PROJECT NAME
**CHILDREN'S HOSPITAL
OF ORANGE COUNTY**
455 S. Main St.
Orange, CA 92668-3874

TOWER II

**LEVEL 1
REFLECTED
CEILING PLAN
AREA - D**

A4.1D

A6 AREA D

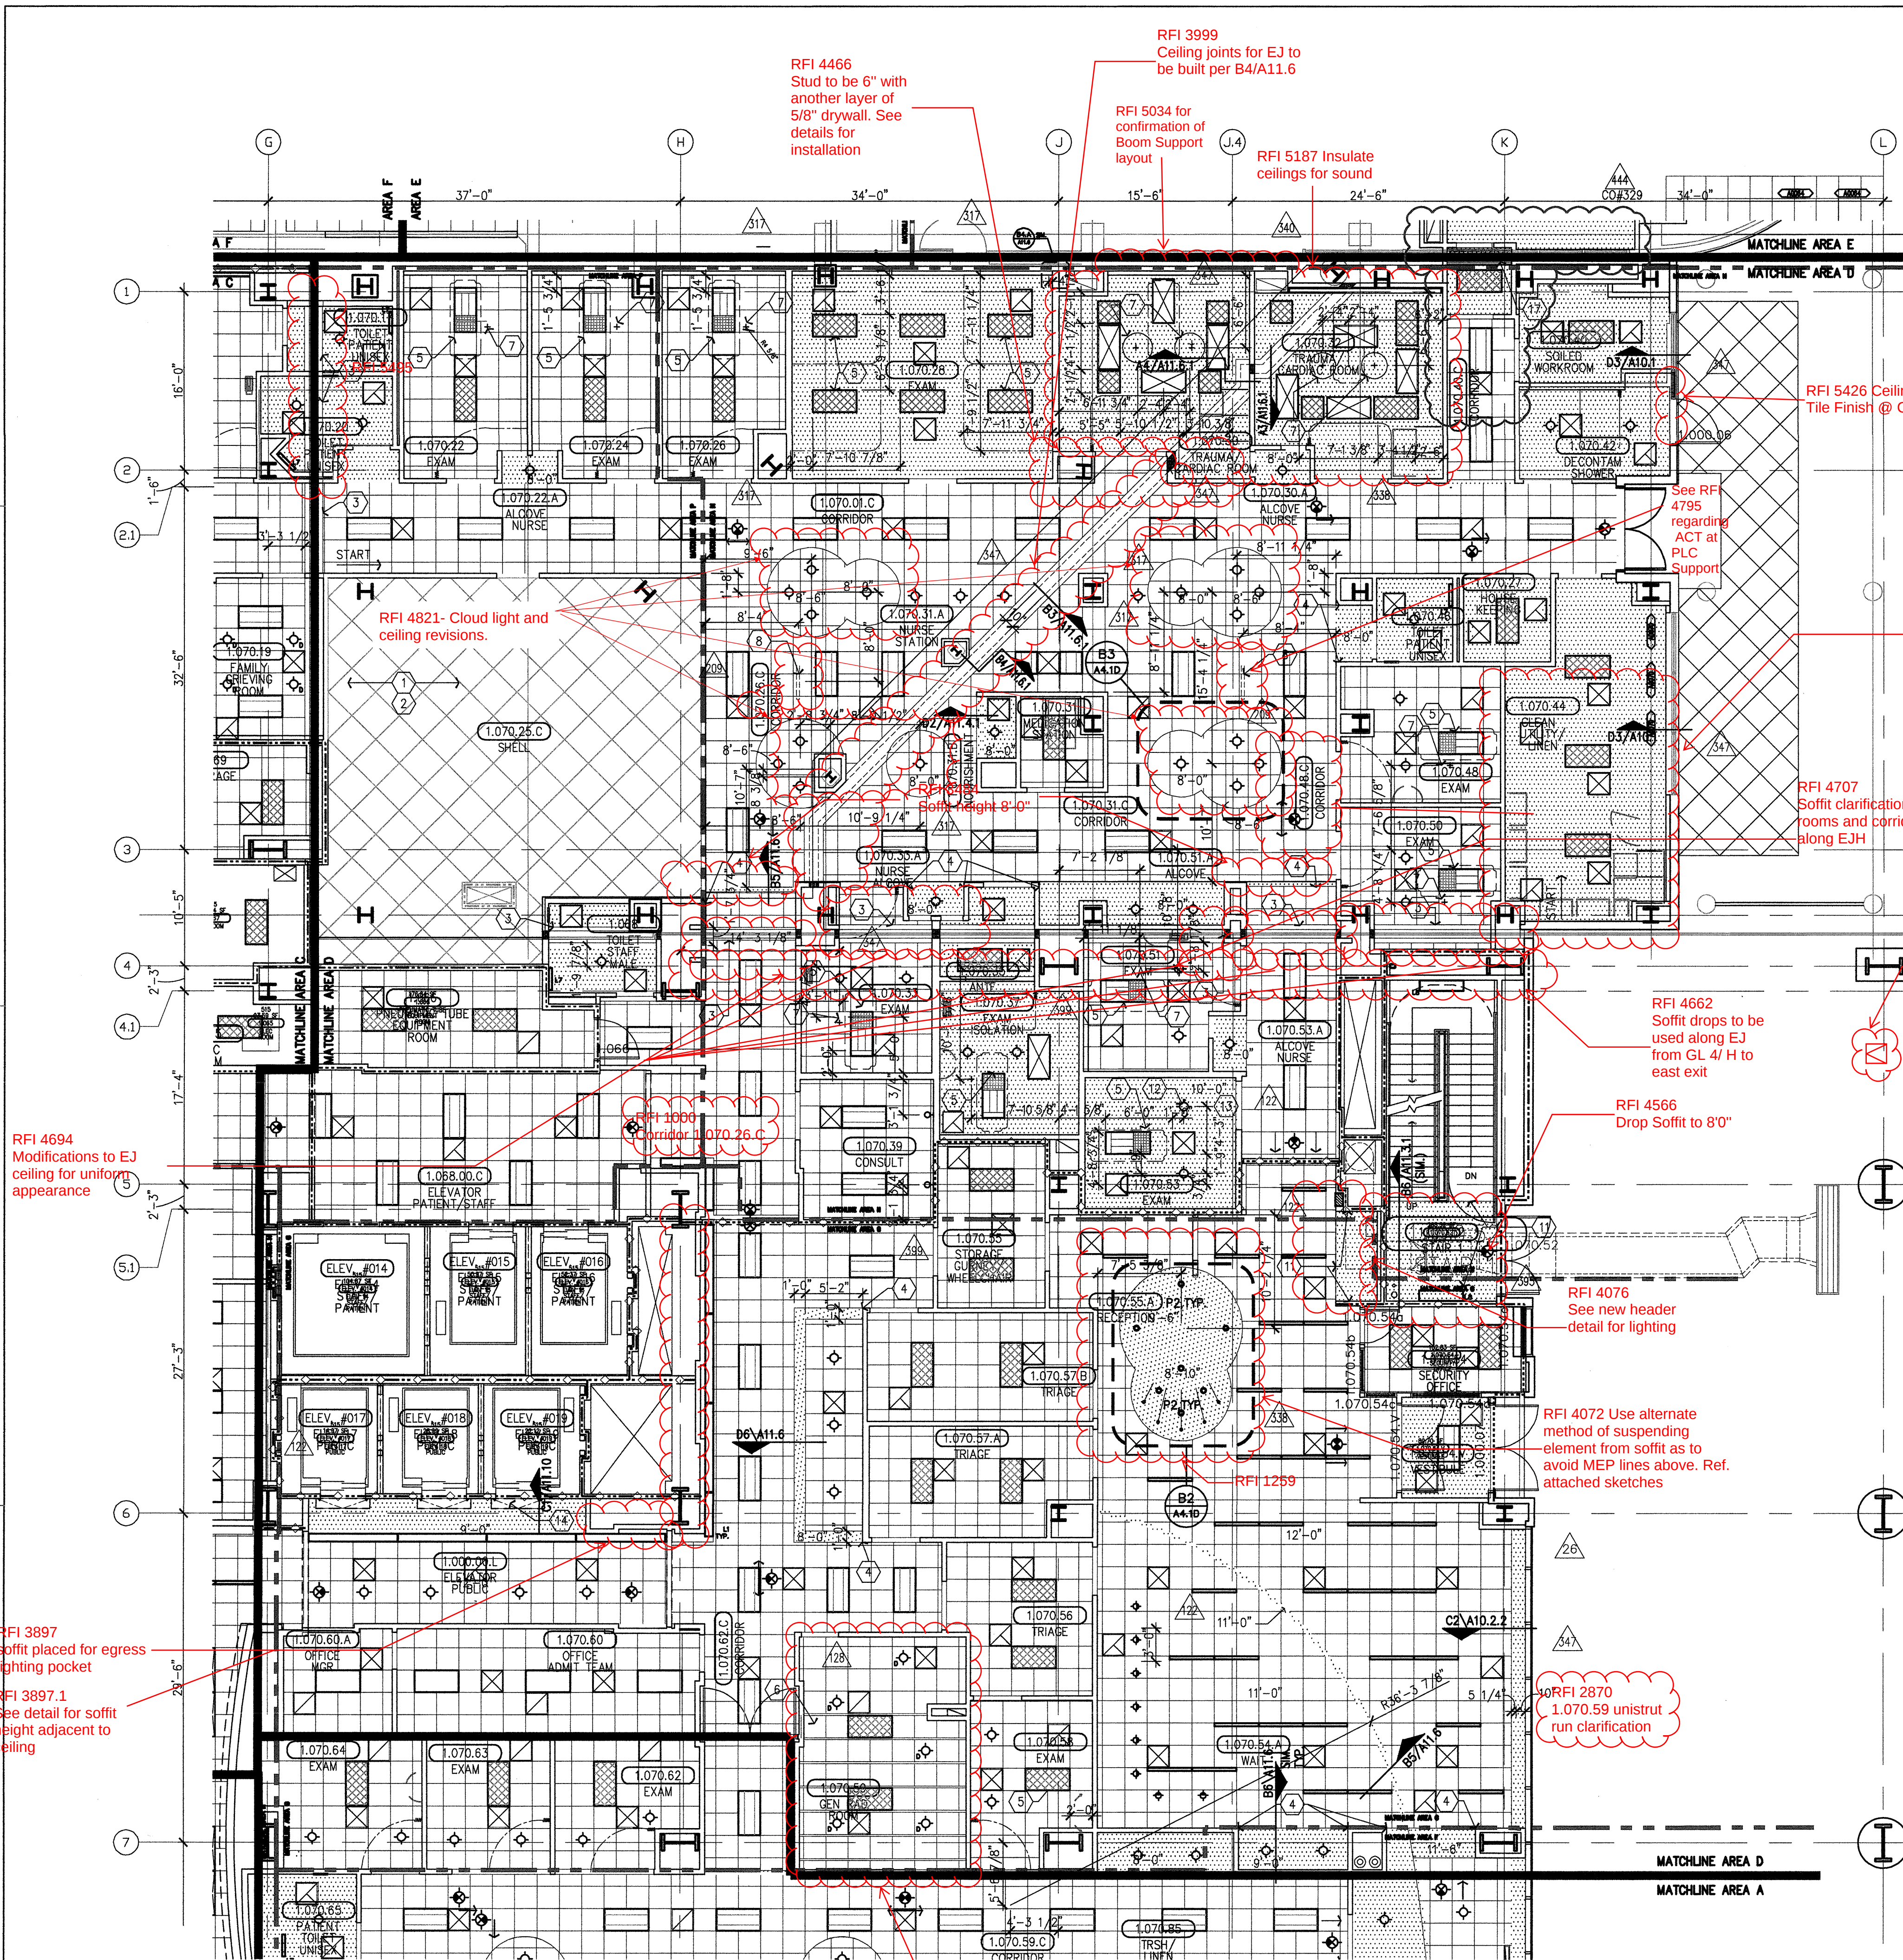
- RFI 4014 See revised ceiling layout per access panel coordination.
